HEAVY VEHICLE ROUTE ASSESSMENT  
- DULGUIGAN ROAD  
ADDENDUM 1  
TUMBULGUM, NSW

## Document Control Sheet

Figure 3.2: Portion of Preliminary Sketch titled "Turns - 19m Semi, Hogans Road Intersection"

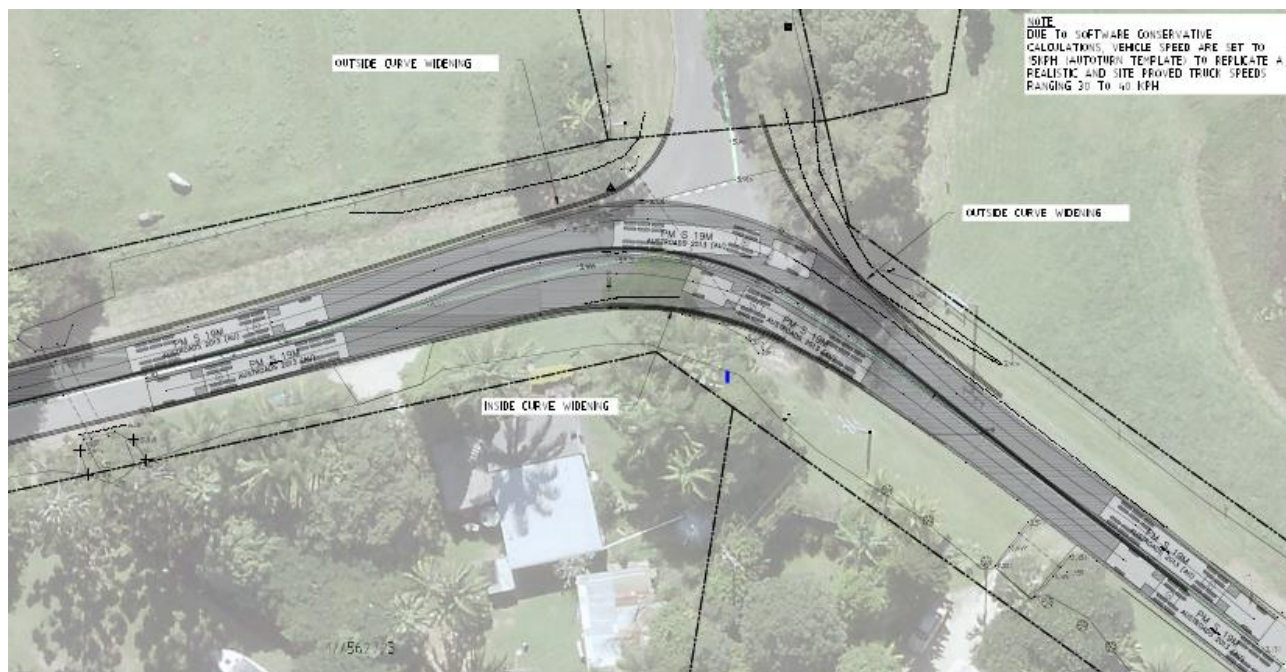
Tweed Shire Council is presently preparing a design that widens the road formation and the road seal at three (3) locations around the curve. The proposed road widening works will cater for a 19m semi-trailer and a 20m PBS vehicle. With reference to *Section 2.1: Control Measure No.1* the 19.6m PBS vehicle travelling at 30-40km/h closely replicates TSC's swept path analysis for a 19m semi-trailer travelling at 15km/h. Therefore, the proposed road widening works at the Dulguigan Road / Hogans Road intersection is based on a 19m semi-trailer travelling at 15km/h as shown in *Figure 3.2* below (Refer *Appendix G: Proposed Road Widening at Hogans Road*).

Road widening works will assist all road users in safely negotiating the curve on Dulguigan Road in either direction, as well as assist all road users when undertaking the various traffic manoeuvres at the Dulguigan Road / Hogans Road intersection.

Figure 3.3: Portion of Preliminary Sketch titled "Turns - 19m Semi, Tumbulgum Section"

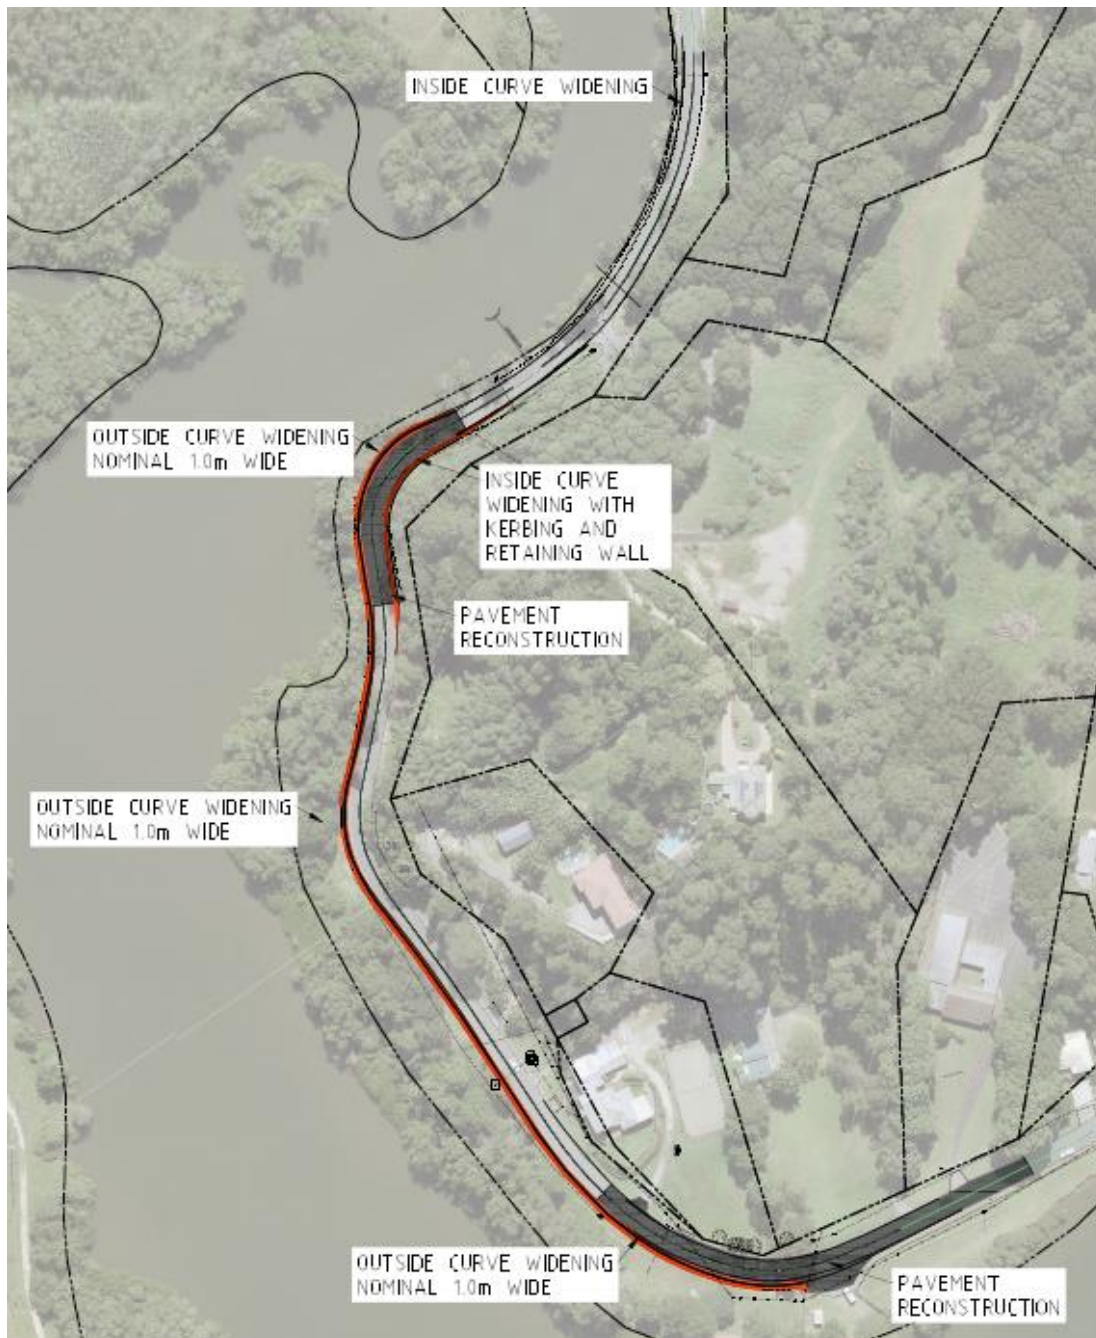
Tweed Shire Council is presently preparing a design that widens the road formation around the series of curves located east of Mayes Hill Road. The design also includes pavement reconstruction at two (2) of the curves.

With reference to *Section 2.1: Control Measure No.1* the 19.6m PBS vehicle travelling at 30-40km/h closely replicates TSC's swept path analysis for a 19m semi-trailer travelling at 15km/h. Therefore, the proposed road widening works on the curves east of Mayes Hill Road is based on a 19m semi-trailer travelling at 15km/h as shown in *Figure 3.3* below (Refer *Appendix H: Proposed Road Widening East of Mayes Hill Road*).

# Quarry Entrance

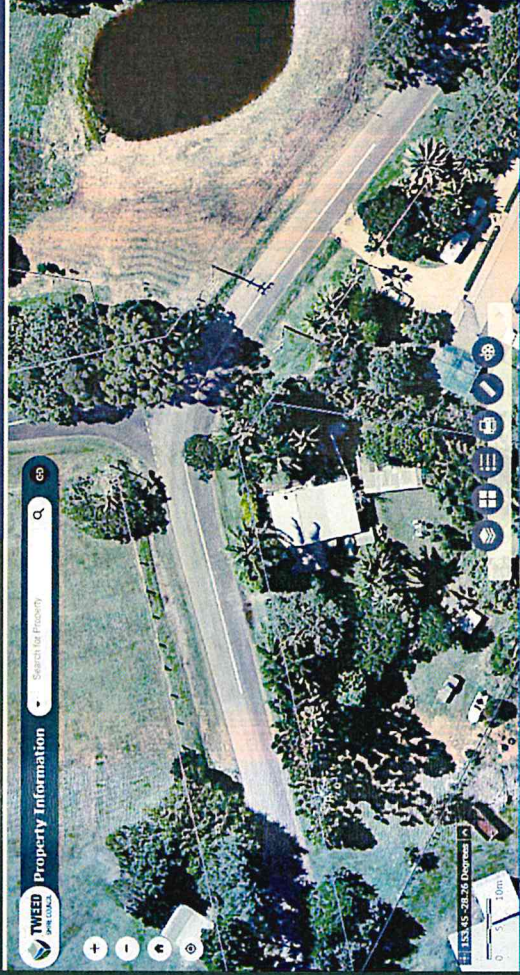
Entrance designed for max 40 x 20m<sup>3</sup> trucks on any given day and 10,000 p.a. as condition - 2004 Quarry DA04/0162

Study identifies vehicles crossing onto opposite side of road when turning east into 100 kpm traffic

**Risk Control Measure**  
relies on behaviour change  
**lowest order safety control**

Note: Unless entrance is redesigned, safer for traffic to enter from and leave the quarry to the west, where it is easier for trucks to stay in correct lane.

# 4. Mayes Hill Curves High Risk

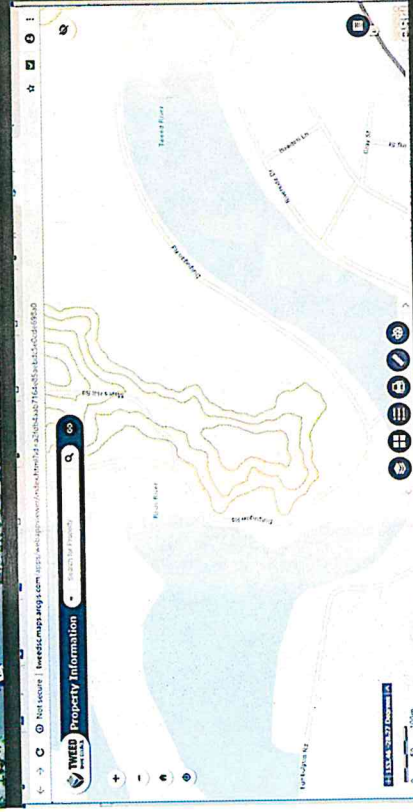
Truck rollover on approach from west c. 2011

To reduce the risk to medium requires major work - acquisition of properties and redesign of curves.

? Achievable      ? Realistic

## 5. Terranora Rd Intersection

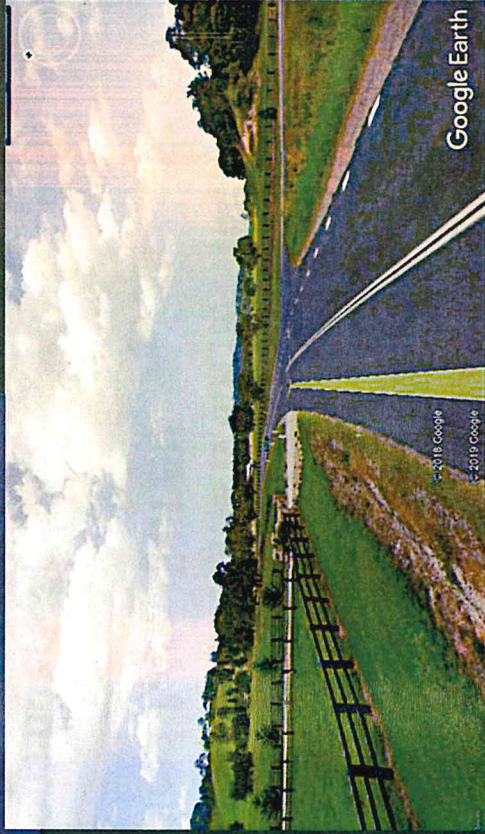
Low risk ????

Proposed right turning lane in Dulguigan Rd does NOT address the community concern of cars travelling north east along Terranora Rd being run off the road by trucks turning left on Terranora Rd from Dulguigan Rd **NO Verge**

## 6. Terranora Rd and Riverside Dr Intersection

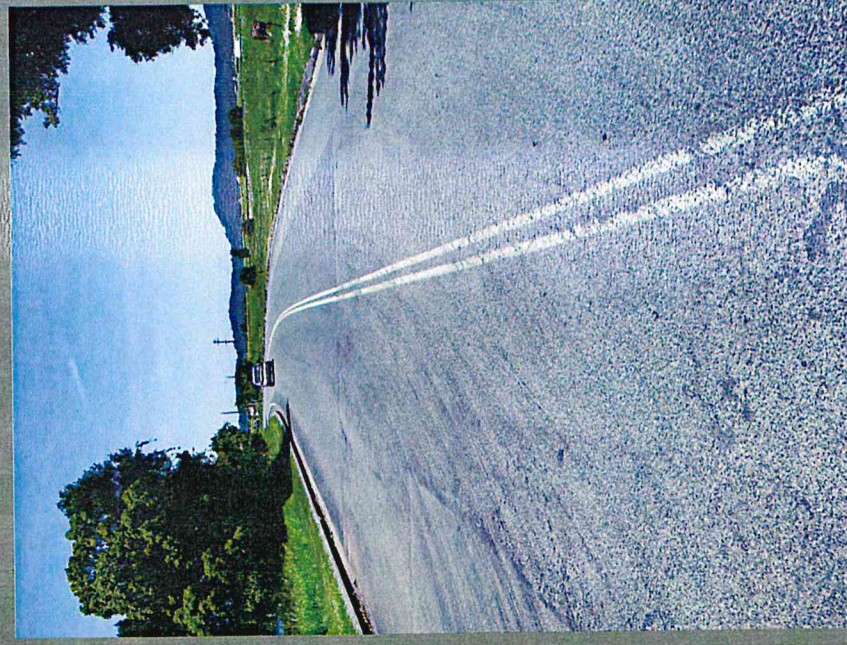
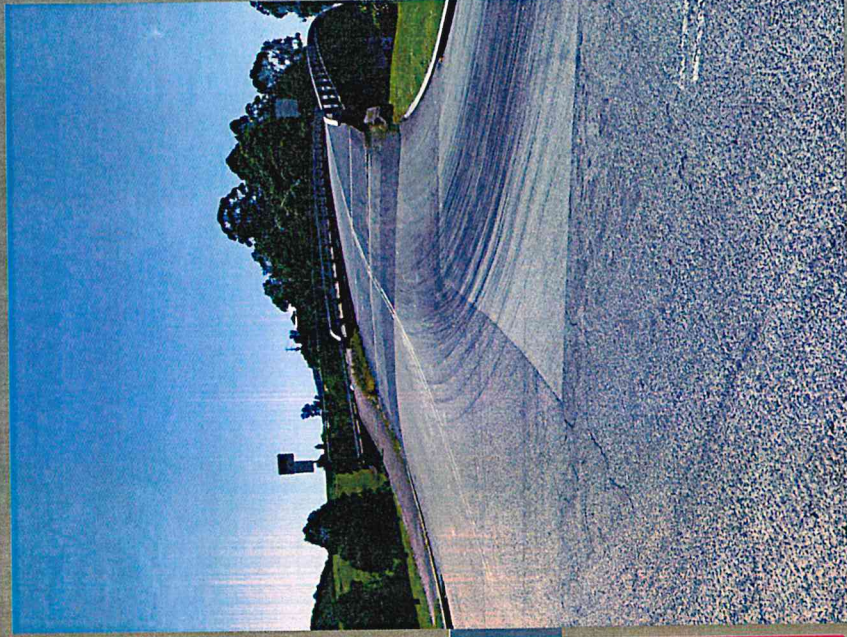
**Medium risk** for Trucks turning  
onto Bridge

### **Incomplete assessment**

Actions not clear

\$\$\$ and timeframe **not** identified
